SUSPENSION—VEHICLE SITS LOW IN REAR	Article No. 00-10-6

FORD: 1998-2000 RANGER

This TSB is being republished in its entirety to add a Note to clarify the parts application.

RANGER 4X2
REAR SUSPENSION

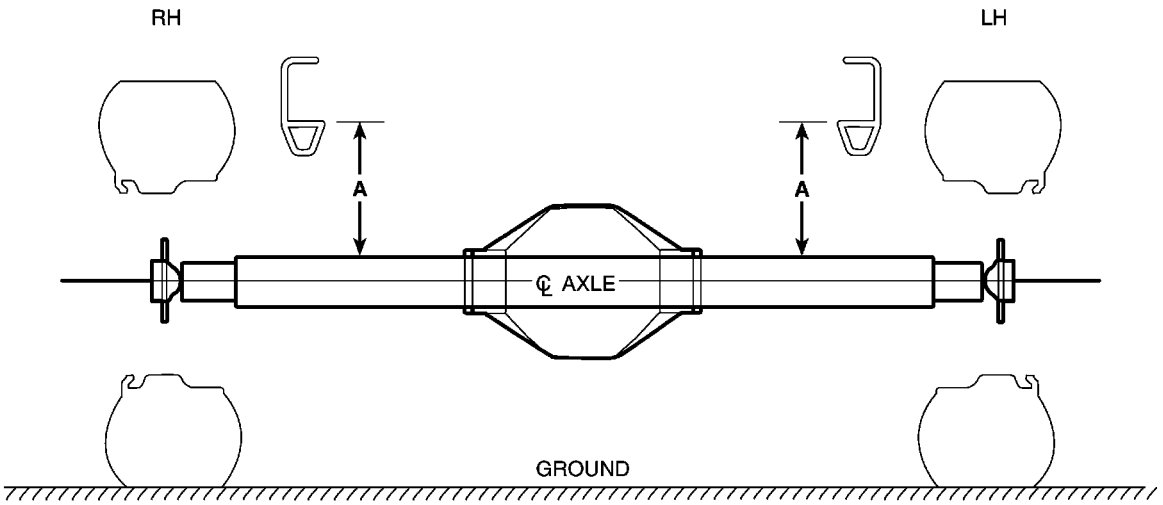
Some vehicles may appear to be low in the rear. This may be caused by the rear springs.

a. For 4X2: Measure from the top of the axle to the bottom of the frame in the area near the middle of the jounce bumper. The rear height for 4X2 should be at a minimum 170mm (Figure 1).

Replace the existing rear springs with revised springs. The revised springs provide a higher ride height at curb and reduce the possibility of the rear being too low. Refer to the following Service Procedure for details.

2. If the vehicle is below the minimum specifications noted, remove existing rear springs and replace them with revised springs. Refer to the appropriate Ranger Workshop Manual for replacement procedures.

RANGER 4X4
REAR SUSPENSION

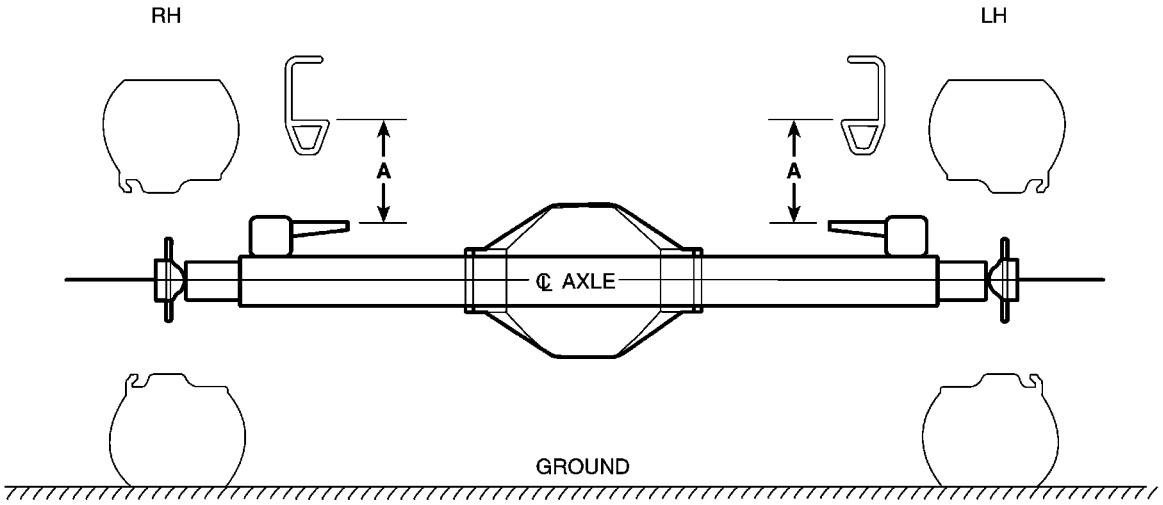
b. For 4X4: Measure from the top of the spring spacer bar to the bottom of the frame in the area near the middle of the jounce bumper. The rear height for 4X4 should be at a minimum of 156mm (Figure 1).
